Project Name:	<b>409 Cumberland Apartments</b>	Project ID:	2013-148
Address:	409 Cumberland Avenue	CBL:	036 H018001/H019001
Applicant:	Seth Parker, Avesta Housing		
Planner:	Caitlin Cameron, Urban Designer

**Re: 409 Cumberland Avenue Apartments  
Responses to Staff Review Pre-Load Permit Request**

**Title:**  
PRELOAD/SURCHARGE PLAN

Title: **PRELOAD EROSION AND SEDIMENTATION CONTROL PLAN**

3 TRAFFIC WARNING SIGNS (YELLOW)  
NOT TO SCALE

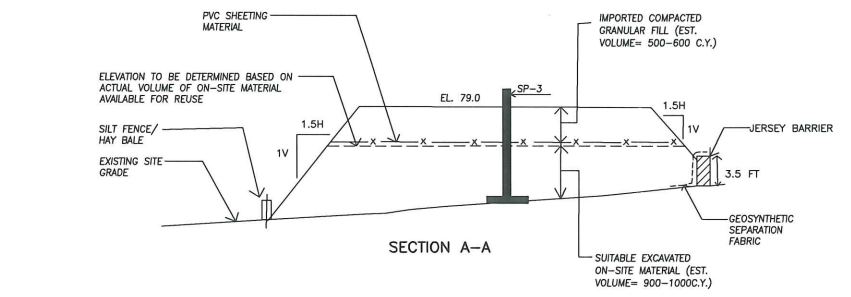
20. Please show detail/location of proposed signage informing motorist of “Revised Traffic Pattern Ahead.”

*The plan has been revised to show location of required signage and a detail has been added to the plan set.*

4 PRELOAD/SURCHARGE GRADING PLAN  
SCALE: 1"=20'

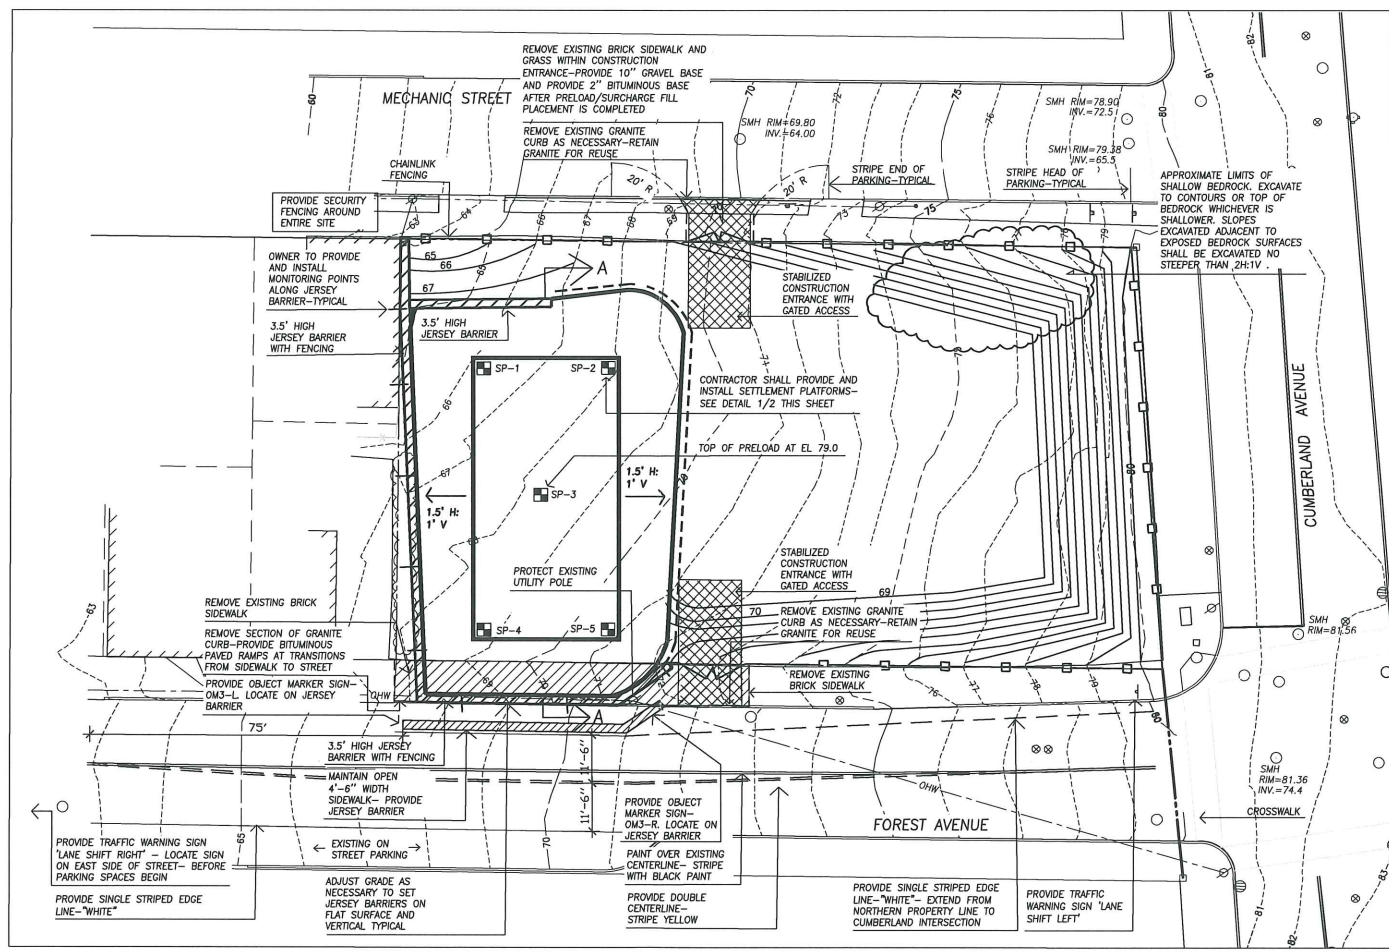
16. On Sheet 2 of the Pre-Load plan, the applicant is requested to indicate width of proposed road markings. Please show the proposed “four inch solid white” pavement marking on the North side of Forest Ave continuing a consistent 7” off the curb line from the proposed Jersey barriers to the intersection of Cumberland Ave intersection.

*The plan has been revised to show the four inch solid white line extending to the intersection with Cumberland Ave off-set 7’ from the curb line on the North side of Forest Ave.*
